Locomotive Standards Committee

January 1958

II.—REPORT OF THE XXXVIII MEETING OF THE LOCOMOTIVE STANDARDS COMMITTEE HELD AT KHARGPUR ON 7th JANUARY, 1958

D. Report of the XXXVIII Locomotive Standards Committee January, 1958

DRG. No. C. S.L. 2718

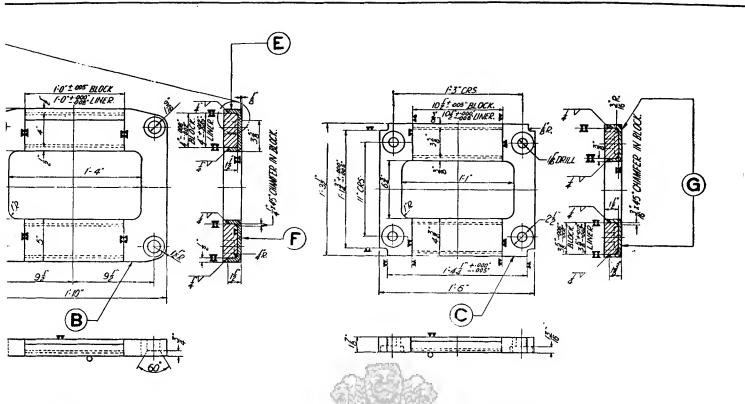
The provision of manganese liners on the inter rubbing blocks of WP locos and the insertion of 2 piece make-up liners behind the engine rubbing block are shown in CSL Drg. 1957. The above features have been incorporated on a large number of new WP, WG and WL locos. Although instructions had been issued to Railways to follow the above CSL Drg. on existing WP locos, it appears that much progress has not been made owing to difficulty in procuring manganese liners and in having to replace the original engine rubbing blocks.

The Western Railway have, as an alternative, modified the original casting of inter rubbing block and fitted "U" shaped spring steel liners which are required to be inserted in place, and claim that this modification which has been applied to all the original WP locos on their system has proved satisfactory in service, although one or two instances have come to notice of the liners dropping off in service. On laying out on the drawing board, it is observed that on 1 in 8½ turnouts and 10° curves, the contact zone falls outside the liner which, thus relieved of the inter buffing load, is liable to get dislodged and fall off, in case the liner is a slack fit on the block.

- (i) whether manganese liners should continue to be fitted on new builds;
- (ii) whether on 270 out of the original lot of 300 WP locos, the proposal outlined in Western Railway drawing should be adopted in preference to the modification shown in CSL Drg. No. 1957 which has been followed on the remaining 30 WP locos.

Para 2. The Committee recommends that the design as shown on CSL Drg. 1957 Alt. No. 2, but with a single piece make-up liner, should continue as standard. The Committee also recommends that it should be left to the descretion of railways to adopt a design of spring steel liner similar to that shown on Western Railway Drg. No. LRB 1726 Alt. No. 1, as and when manganese steel is not available for replacement purposes.

Para 2. Approved. R.D.S.O. should prepare drawing showing application of spring steel liner as alternative to manganese steel liner for new builds and replacements.
